SKEP III Home Office Support Site Visit Report

Consultant	Wahib Medanat Consultant Engineer	Rep No.	21-15062022
Contractor	Dijlah Establishment Constr. Contracting	Tender No.	(11/2019/USAID/SKEP/3/S) Schools for a Knowledge Economy Project (SKEP) - Phase (3) Package (1, 2)
Site Name	Hay Al Iskan Basic Mixed School- Jerash	Day/ Date	Wed. 15/06/2022
Duration of Project	450 Calendar Days	Total Project Budget	8,314,983.735 JD

(Figure: 13)

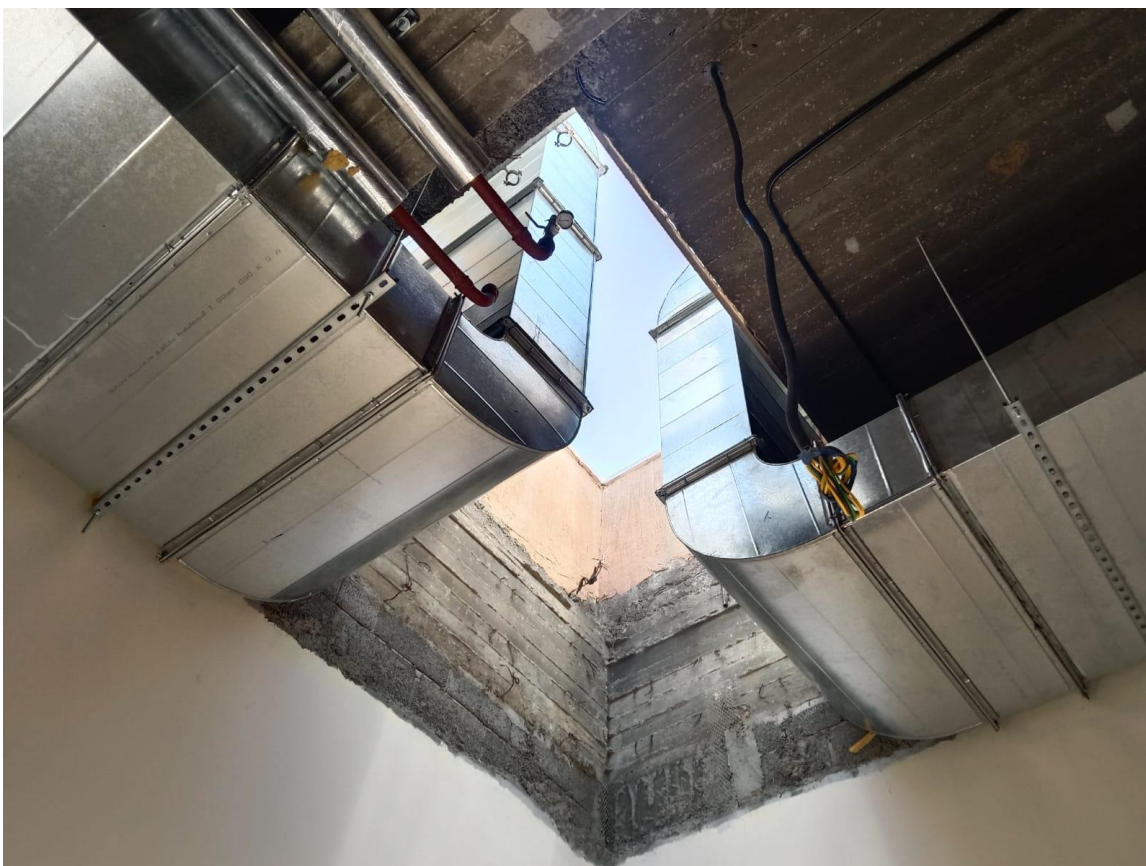
The team observed that the rubber fixed for aluminum windows should continue all over around the glass panel
